Project No. 21-109

RE: DEP FILE E0205225-004
Technical Deficiency Response Letter
Quaker Valley High School New Campus
Leet Township, Leetsdale & Edgeworth Boroughs, Allegheny County, PA

On behalf of Quaker Valley School District, Streamline Engineering, Inc., submits this letter in response to DEP's technical deficiency letter dated June 16, 2025. This letter describes changes to the campus design as a result of discussions with DEP during a site meeting held on May 21, 2025 and revisions to the Joint Permit Application as a result of the design changes and the responses to the comments.

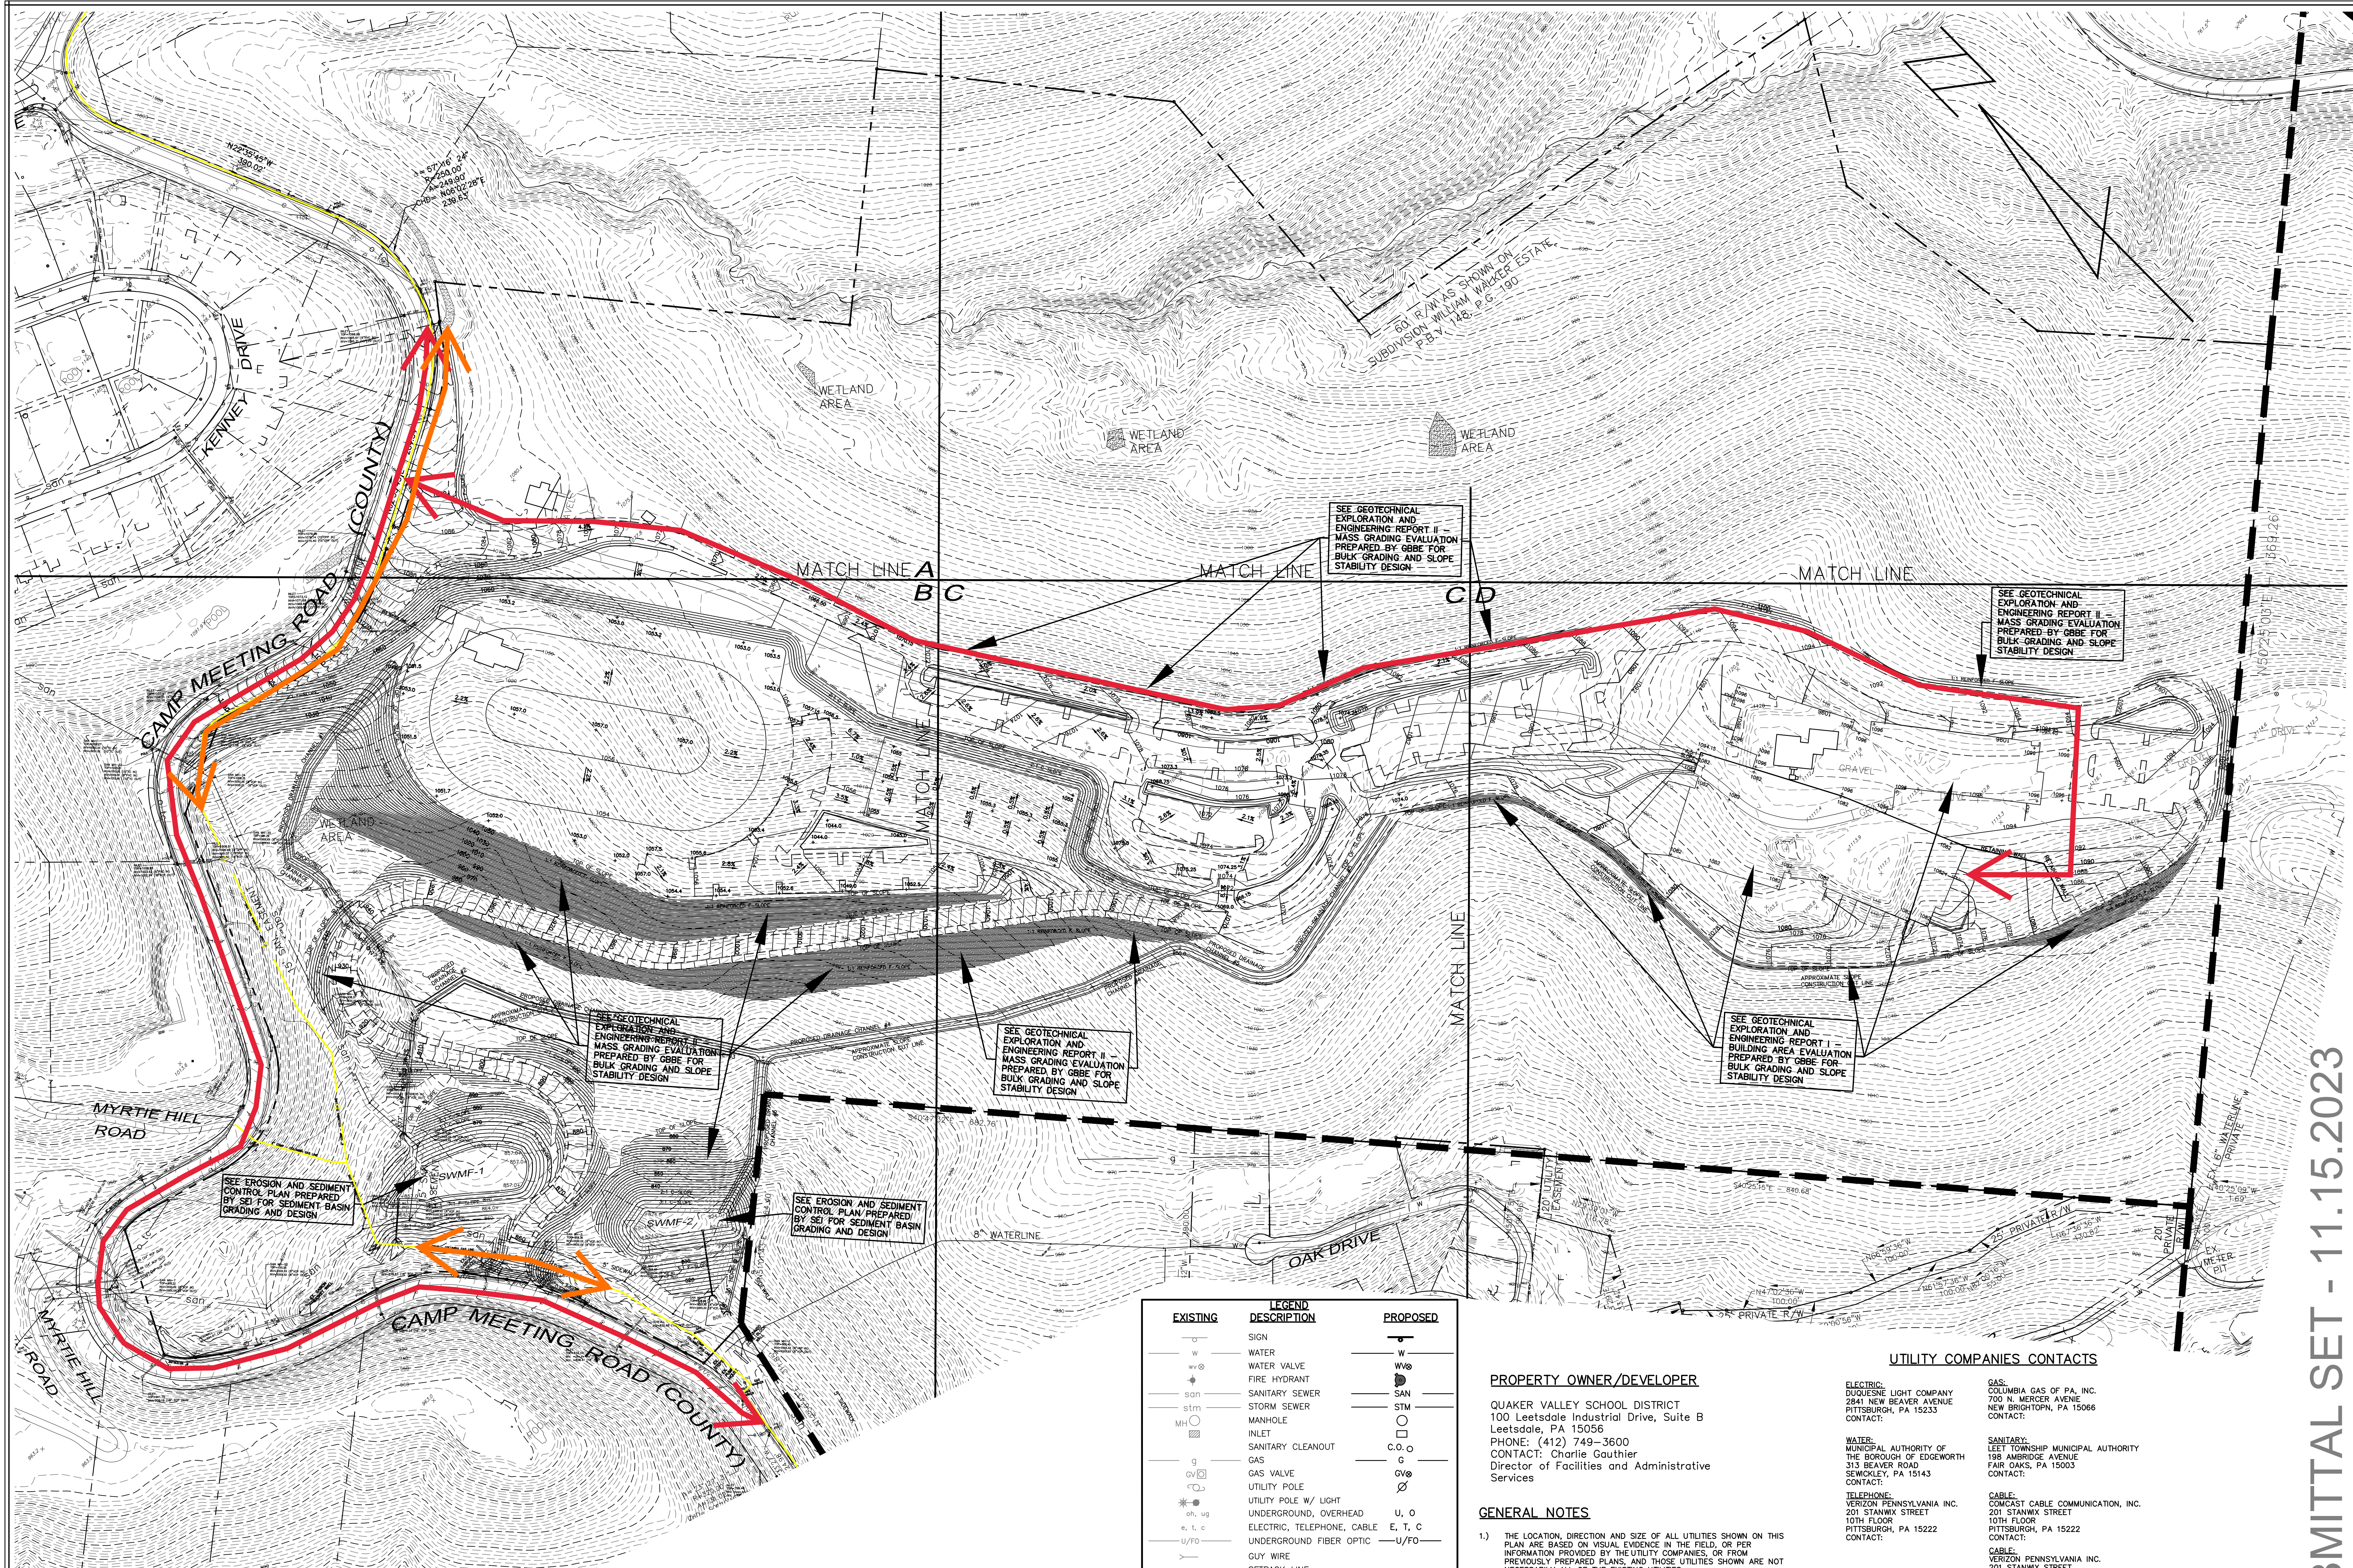
Attached is a mark up of Columbia Gas's proposed replacement/relocation project on Camp Meeting Rd. We are committing at a minimum that we will relocate the section of the pipeline that is in conflict with the southern entrance to the school (orange arrow). We are looking into the scope of expanding the replacement of this project (red arrow on Camp Meeting Road), but we are still looking into the design.

There will also be a ~3,400'-4" gas line installed to service the school as well.
